**Redegørelse i anledning
af tre havarier
med Dash8 Q400**

Bilag til redegørelsens kap. 6

Genaktivering af luftdygtighedsbeviser på luftfartøjer af typen Bombardier DHC8-Q400.

1 TITLE Rework instructions for trimming the lower edge of the Nose Landing Gear Door Mechanism Debris Guard, P/N 83220012, to remove / prevent chafe damage with the spring assembly			2 RD NUMBER 8/4-32-064	
			3 SECTION I	4 SHEET I
5 PRIME DESIGN ACTIVITY BOMBARDIER INC., DOWNSVIEW 71867	6 ADDITIONAL LIMITATIONS NONE	7 SERIES DHC-8-400 Models 401 / 402	8 APPLICABILITY S/N All

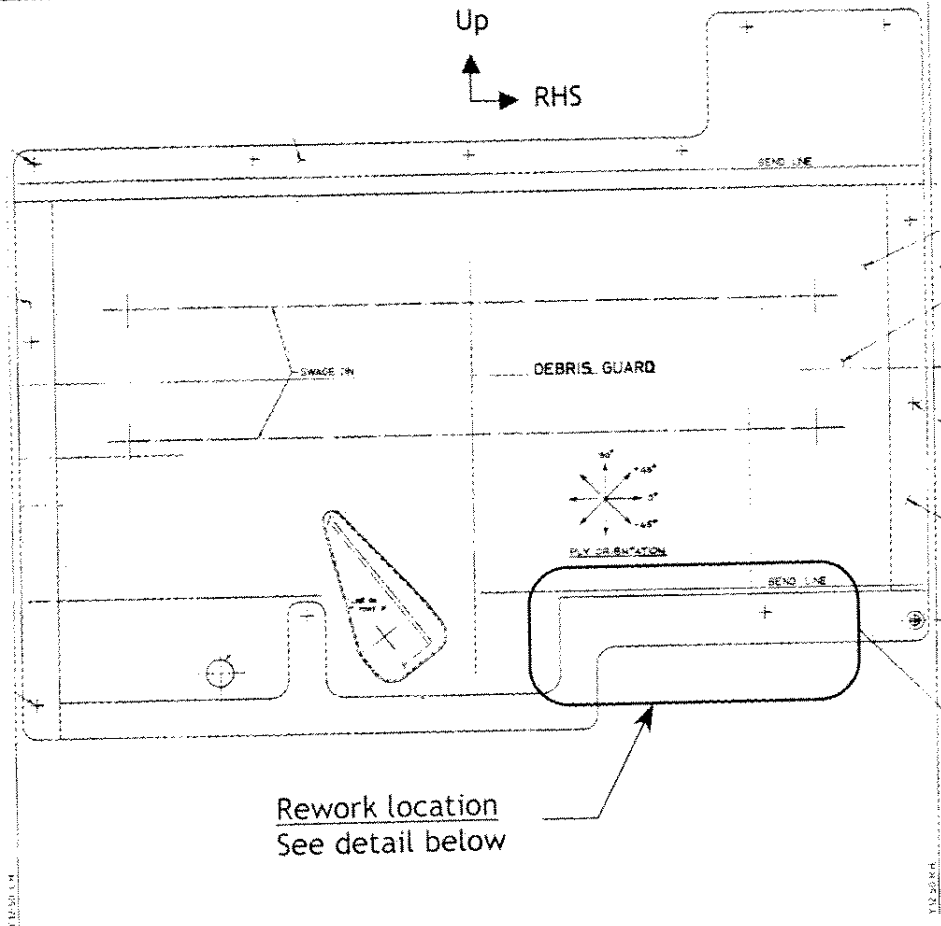
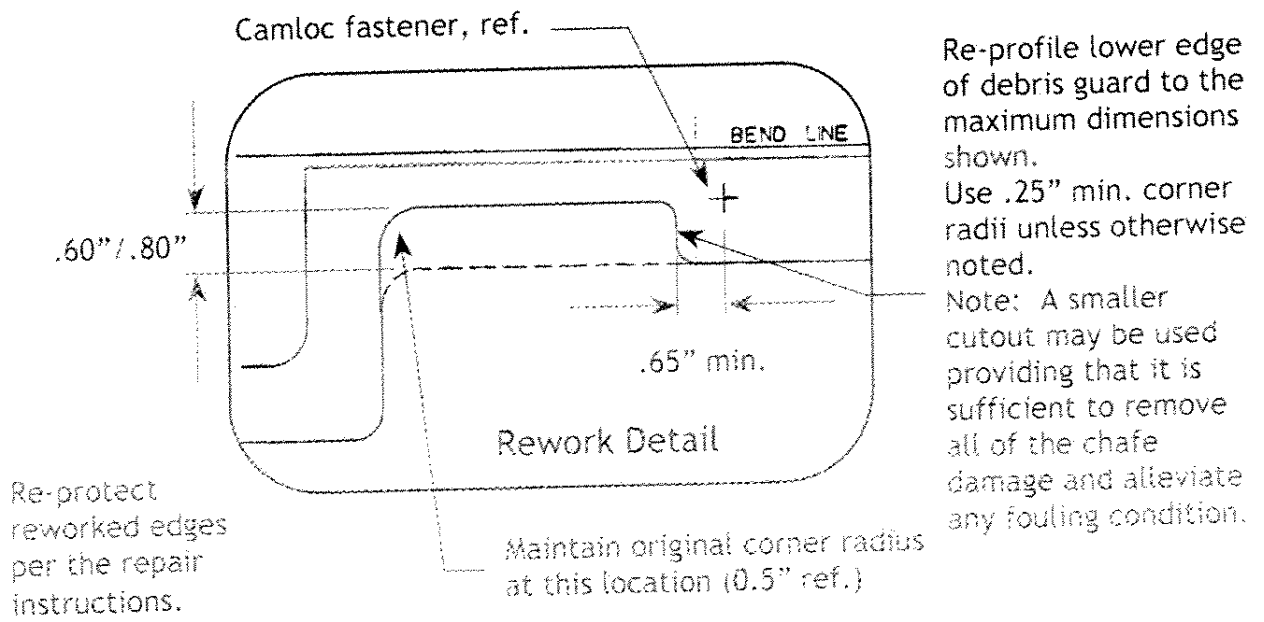
1. Re-profile the lower edge of the nose landing gear door mechanism debris guard, P/N 83220012, as shown on Sheet 2.

Maintain maximum cutout dimensions and minimum distance to the adjacent Camloc as shown on Sheet 2. Ensure that all chafe damage is removed by the cutout.

Note: In lieu of the maximum cutout shown on Sheet 2 a smaller cutout may be used provided that the min. corner radii and distance from the Camloc is maintained and that all of the damage has been removed.

FIGURE 1.

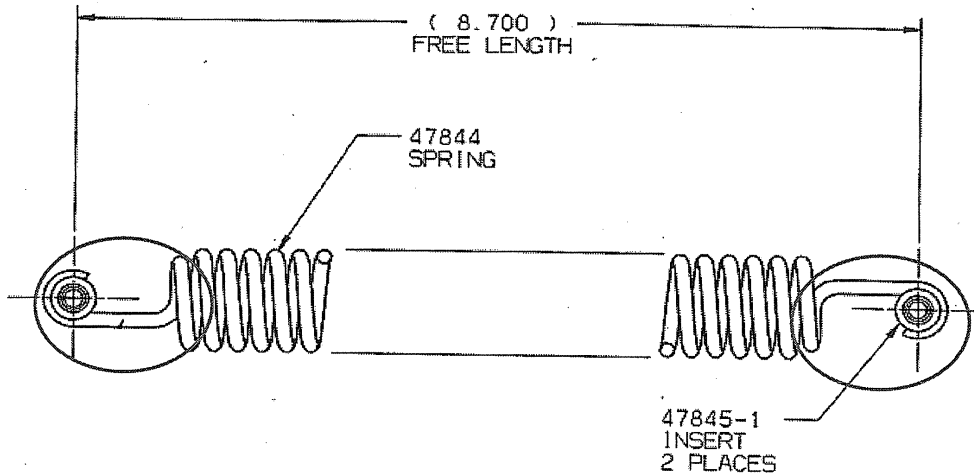
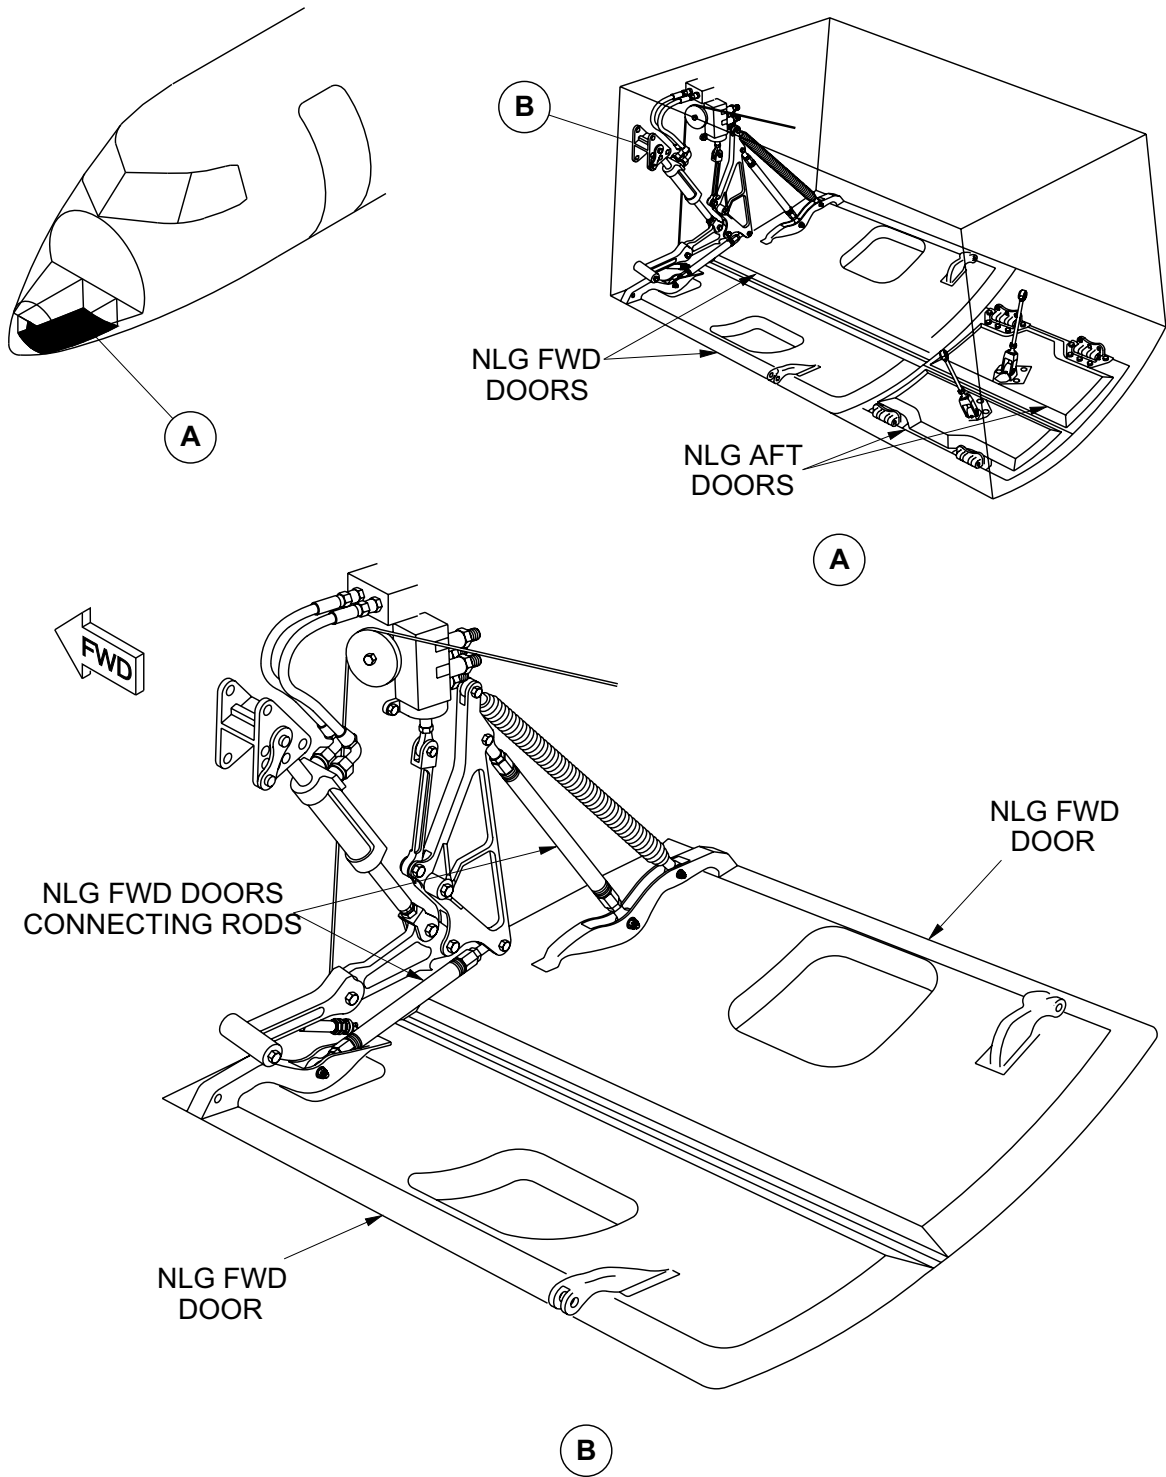
ITEM	PROBLEM DESCRIPTION
1.	NLG FORWAD DOOR SPRING P/N 47844-1 MAY FAIL AND SEPARATE FROM MOUNTINGS PRESENTING A F.O.D ISSUE FOR THE NLG. SEE SHEET 4 FOR LOCATION INFORMATION.
REPORTED CAUSE OF PROBLEM:	
ADDITIONAL INFORMATION ATTACHED <input checked="" type="checkbox"/>

CRITICAL AREAS FOR VISUAL INSPECTION AND LIQUID PENETRANT INSPECTION ARE HIGHLIGHTED ABOVE.

5. IF DAMAGE IS IDENTIFIED IN OPER #3, AND PART MEETS ACCEPTANCE CRITERIA OF OPER #4 (LPI), LIGHTLY POLISH AREAS SHOWING EVDIENCE OF SCRATCHES OR CHAFE DAMAGE AS REQUIRED TO JUST REMOVE ALL SHARP EDGES, NO POWER TOOLS PERMITTED.
 - DO NOT DEEPEEN
 - MAX DEPTH OFDAMAGE NOT TO EXCEED .006 INCH.
 - IF MAX DEPTH EXCEEDED DISCARD PART.
6. ENGINEERING EVALUATION SHOWS ANY/ALL SPRINGS REWORKED IN ACCORDANCE WITH OPERATION 7, AND/OR HAVING LONGITUDINAL PLAY BETWEEN THE RETAINER AND SPRING ARE ACCEPTABLE FOR **250 A/C FC** OF CONTINUED SERVICE. WHEN FLIGHT CYCLE ALLOWANCE IS EXHAUSTED, DISCARD SPRING ASSEMBLY.
7. REASSEMBLE FWD DOOR LINKAGE WITH NEW OR SERVICABLE SPRING P/N 47844-1, AND RIG ACCORDING TO BOMBARDIER AMM PROCEDURES.
8. PERFORM ANY/ALL RETURN TO SERVICE ACTIONS IN ACCORDANCE WITH BOMBARDIER AMM.

FIGURE 1

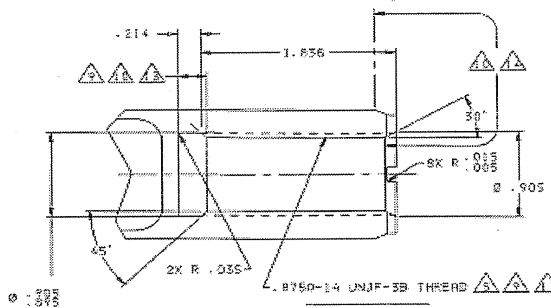
10. VISUALLY INSPECT PISTON (P/N 46570-1/-3) THREADS AND THREAD RELIEF AREA FOR EVIDENCE OF CORROSION AND/OR DAMAGE AND/OR PITTING (REF. FIGURE 1), USING 10X MAGNIFICATION MIRROR OR BORESCOPE UNDER ADEQUATE LIGHTING CONDITIONS.
 - IF CORROSION IS FOUND IN THREADED AREA OF PISTON P/N 46570-1/-3 PERFORM REWORK IN ACCORDANCE WITH **SECTION B** OF THIS SCR
 - IF NO CORROSION IS FOUND CONTINUE WITH REMAINING OPERATIONS

3. INSPECT THE ENTIRE PROFILE OF THREADS OVER THE FULL SPAN OF THREADS (REF. 1.836 DIM, FIGURE 1) AND THE RELIEF GROOVE IN PISTON USING 10X MAGNIFICATION MIRROR OR BORESCOPE UNDER ADEQUATE LIGHTING CONDITIONS.

FIGURE 2

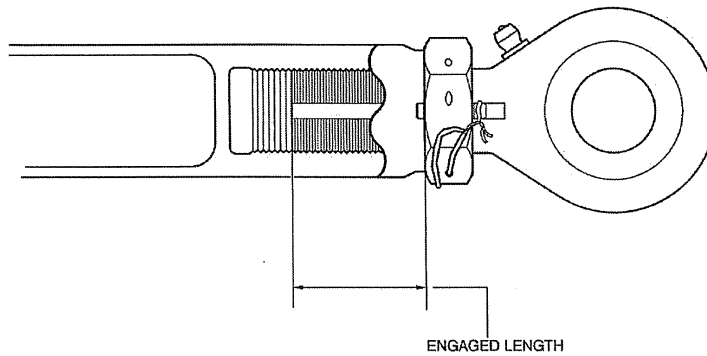
4. **ACCEPTANCE CRITERIA/REWORK OPTIONS**
 - A) LIGHT SURFACE CORROSION (NO PITTING) OVER THE ENTIRE THREADED LENGTH WITH AT LEAST FIVE CONSECUTIVE FULL UNDAMAGED THREADS WITHIN THE ENGAGED THREAD LENGTH (REF FIGURE 2) IS ACCEPTABLE FOR **1000 FC OR 6 MONTHS** (WHICH EVER OCCURS FIRST) OF CONTINUED SERVICE. THE RETRACT ACTUATOR IS TO BE INSPECTED TO ENSURE JAM NUT IS SECURE AND WIRE LOCK IS IN PLACE EVERY **100 FC**

FOR OPTIONS a) AND b), THE RETRACT ACTUATOR IS TO BE INSPECTED TO ENSURE JAM NUT IS SECURE AND WIRE LOCK IS IN PLACE EVERY **100 FC**.

FIGURE 1

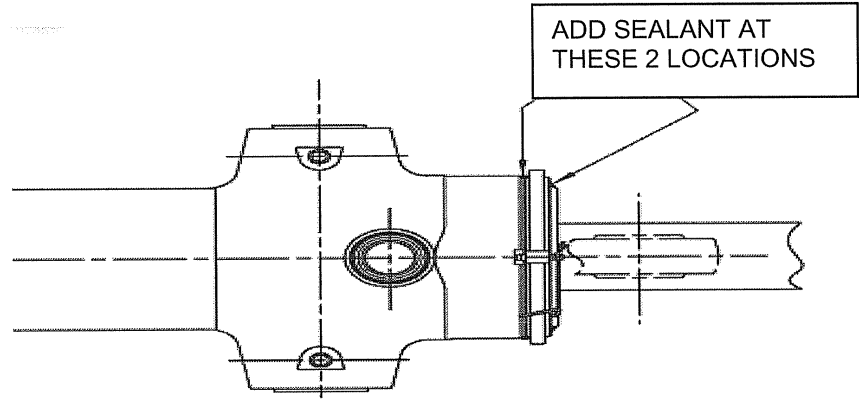
1. CLEAN THREADS USING A STAINLESS STEEL WIRE BRUSH AND SOLVENT, TO REMOVE ALL F.O.D AND CORROSION BY PRODUCTS
2. VISUALLY INSPECT THREADS AND THREAD RELIEF AREA FOR EVIDENCE OF PITTING AND DAMAGE TO THE THREAD FORM USING 10 X MAGNIFICATION

4. IF THREADS ARE FOUND TO HAVE PITTING OR DAMAGE TO THE THREAD FORM THEN CONTINUE WITH **SECTION A** OF THIS SCR.
5. LIGHTLY CHASE THREADS USING A WIRE BRUSH OR THREAD COMB AS REQUIRED TO REMOVE ALL EVIDENCE OF CORROSION.

6. LIGHTLY POLISH THREAD RELIEF AREA AND ADJACENT CHAMFER AS/IF REQUIRED TO REMOVE ALL EVIDENCE OF CORROSION.
7. INSPECT – ENSURE ALL EVDIENCE OF CORROSION HAS BEEN REMOVED (NO PITTING) AND THAT THREAD FORM REMAINS UNDAMAGED, USING 10 X MAGNIFICATION.

8. SOLVENT CLEAN REWORKED AREAS PER CMM 32-31-06 REQUIREMENTS
9. TOUCH UP BRUSH CAD PLATE REWORKED AREAS PER CMM 32-31-06 REQUIREMENTS (REF. FIGURE 2).
10. COMPLETE PART PER CMM 32-31-06 REQUIREMENTS, AND RETURN TO PAGE 2 OF THIS SCR AND COMPLETE REASSEMBLY PER OPERATIONS 5 THRU 10.

FIGURE 1

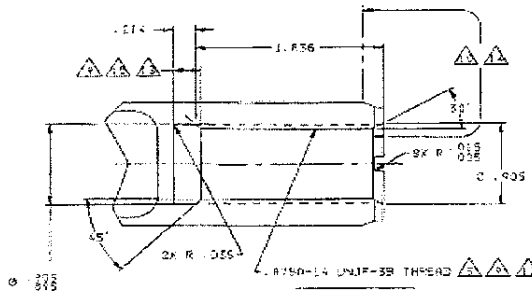
10. VISUALLY INSPECT PISTON (P/N 46570-1/-3) THREADS AND THREAD RELIEF AREA FOR EVIDENCE OF CORROSION AND/OR DAMAGE AND/OR PITTING (REF. FIGURE 1), USING BORESCOPE OR 10X MAGNIFICATION MIRROR UNDER ADEQUATE LIGHTING CONDITIONS.

FIGURE 2

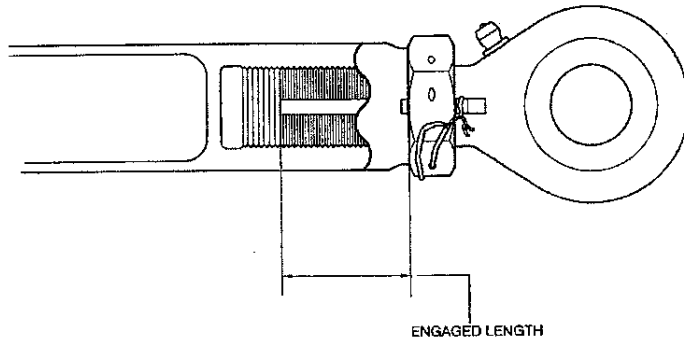
A) LIGHT SURFACE CORROSION (NO PITTING) OVER THE ENTIRE THREADED LENGTH WITH AT LEAST FIVE CONSECUTIVE FULL UNDAMAGED THREADS WITHIN THE ENGAGED THREAD LENGTH (REF FIGURE 2) IS ACCEPTABLE FOR **1000 FC OR 6 MONTHS** (WHICH EVER OCCURS FIRST) OF CONTINUED SERVICE. THE RETRACT ACTUATOR IS TO BE INSPECTED TO ENSURE JAM NUT IS SECURE AND WIRE LOCK IS IN PLACE EVERY **100 FC**

FOR OPTION a) THE RETRACT ACTUATOR IS TO BE INSPECTED TO ENSURE JAM NUT IS SECURE AND WIRE LOCK IS IN PLACE EVERY **100 FC**.

IF JAM NUT IS FOUND LOOSE DURING FLIGHT CYCLE ALLOWANCES GRANTED BY THE CRITERIA IN 4A) OR 4 B), RE-TORQUE JAM NUT TO 660-980 INB-LBS AND SAFETY LOCKWIRE PER MS 33540.

A/C Reg: LV ROE Retract Actuator P/N 46550-7 S/N 0037 Mfg date from placard

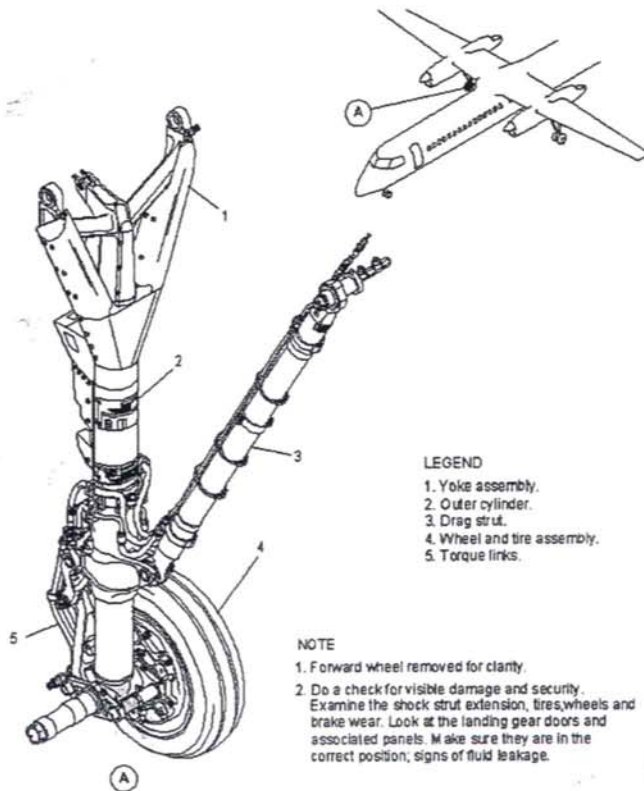
RH - A LITTLE OR NON PLAY BETWEEN PISTON AND BALL JOINT. JAM NOT NOT LOOSE, BALL JOINT STUCK IN PISTON.

A/C Reg: LN-RDI Retract Actuator P/N 46550-7 S/N 0057 Mfg date from placard

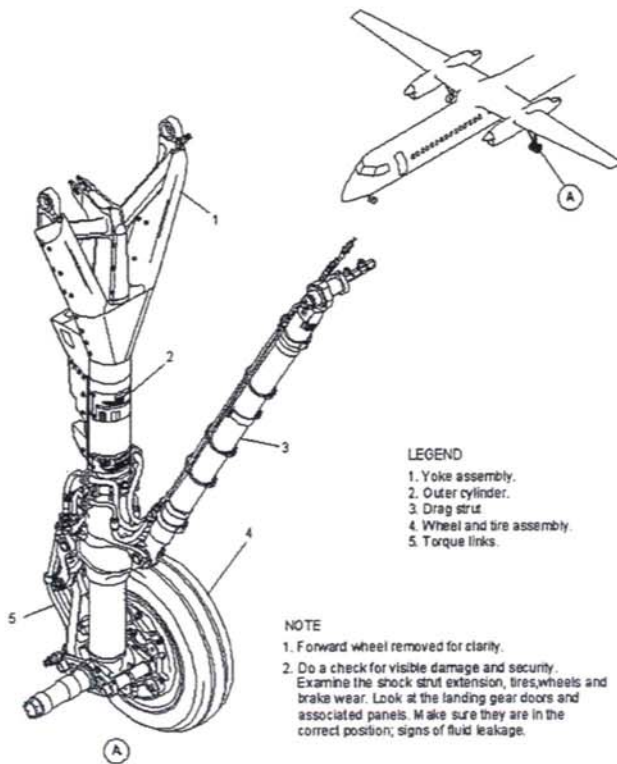
LH - EXTENSIVE PLAY BETWEEN PISTON AND BALL JOINT AND LOOSE JAM NUT.
